TITLE HIGH RELIABILITY THYRISTOR (TRIAC)			PIB NO. DK- 3005
PRODUCT LINE:	TAPE DISK FORMATTER <input checked="" type="checkbox"/>	EQUIPMENT CHANGED MCB (Motor Control 102826-XX Ed.)	MODEL SERIES AFFECTED D3000
			EFFECTIVE DATE 11-5-73

TITLE HIGH RELIABILITY THYRISTOR (TRIAC)

PIB NO.
DK- 3005

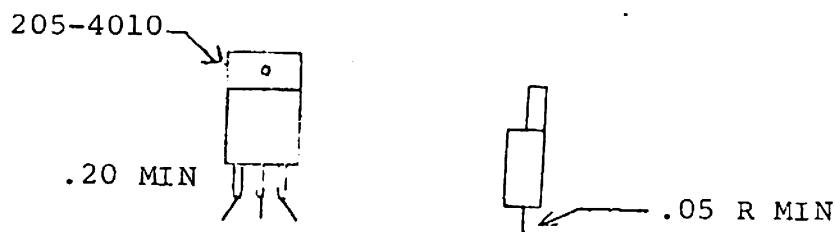
The lead to lead spacing of the (new) triac, 205-4010, is narrower than the original triac (205-0106). The two outside leads of the new part shall be bent outward slightly to attain the proper lead spacing as shown below:

DETAIL "A"

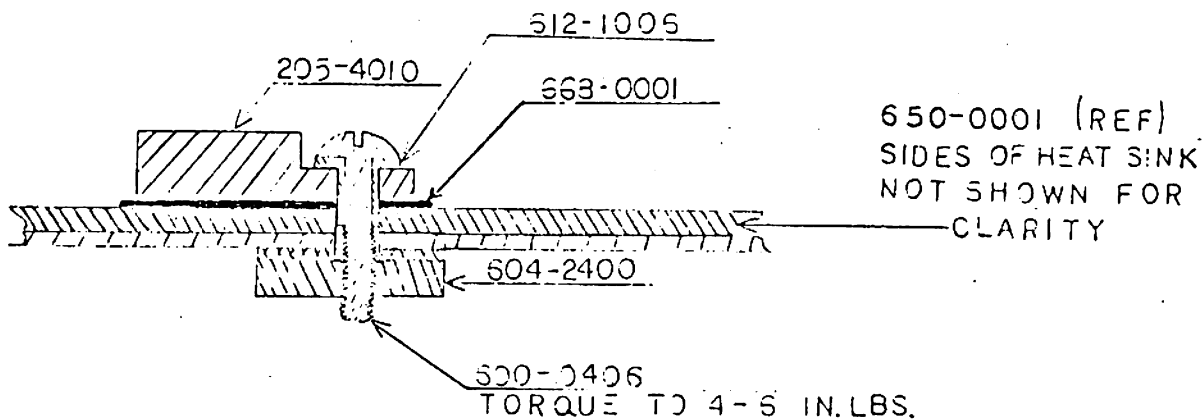
When mounting the 205-4010 triac to the process board, use the hardware configuration shown.

INSTALLATION INSTRUCTIONS: Apply 360 silicon heat sink compound to triac (90% min. coverage) and to mounting surface before installation.
(Cont.)

If new hardware is not available, use existing hardware deleting the #6 flat washer (606-0600).

102826 Zone 5D Delete: 600-0606
604-0600
606-0600
(Torque to 8 to 12 in. lbs.)

Zone 5D Add: See Detail "A" for hardware Stack Up.

Zone 5, 4D
Delete: (Use lock washer & mica washer supplied with 205-0106).
Add: View, Detail "A" to face of drawing.
